ATTACHMENT 1

HOW TO READ THE ATTACHED DOCUMENTS IN RELATION TO AMENDMENT C 25 & BECTON'S FURTHER SUBMISSION (DATED 15 MARCH 2002)

SCHEDULE 12 TO THE DESIGN AND DEVELOPMENT OVERLAY

ESPLANADE HOTEL SITE

BUILDING ENVELOPE PLAN

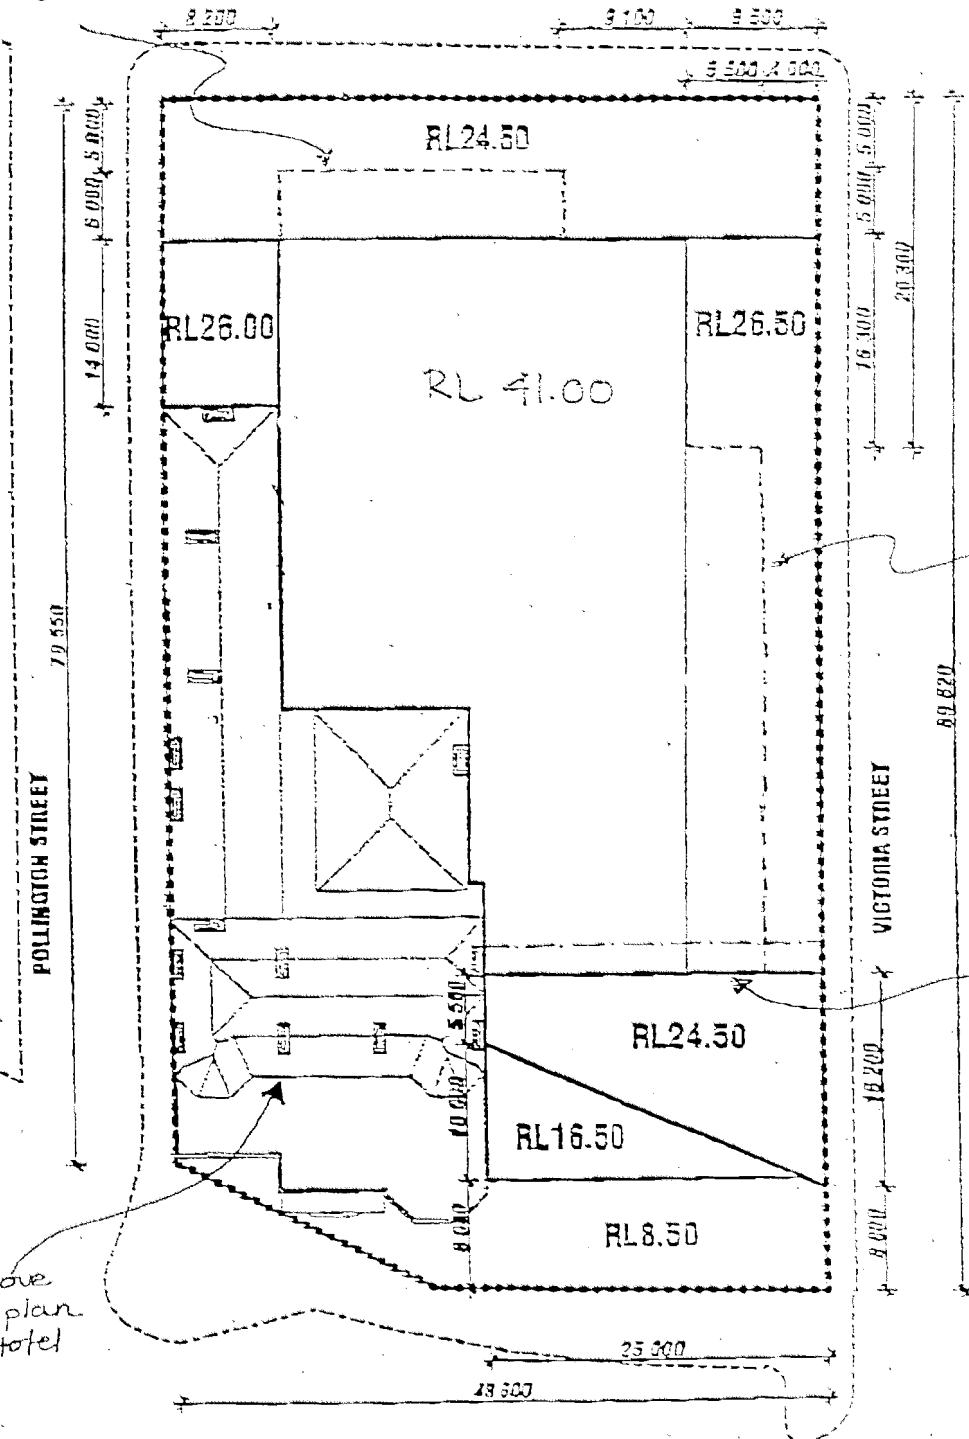
Becton's plan shows a reduction in the width of sections of the building envelope to Pollington Street (east) from 10 to 5 metres and Victoria Street from 9.5 to 4 metres. The envelope to the east of the view cone has been reduced in depth by 1 metre (moved from the roof ridgeline to in front of the nearby chimney).

Section reduced setback - disagree

Add note "Nothing in this plan is to influence any consideration under a"

Bectons' proposed plan and specified maximum heights are supported subject to:

- Maintaining the strategic intent of Amendment C25.
- Including a note in the legend of the plan that reads:

"Nothing in this plan is to influence any consideration under a Heritage Overlay"
- Deletion of the roof plan of the leased portion of the Esplanade Hotel.
- The introduction of a criterion in schedule 12 to the Design and Development Overlay that reads:

"The specified maximum height on plan XX will only be able to be achieved by a building which meets the design objectives and other provisions of the schedule".
- No change to the Pollington Street (east) and Victoria Street envelopes.
- The following outcomes, included in the table to schedule 12, are included as design objectives or building design provisions:
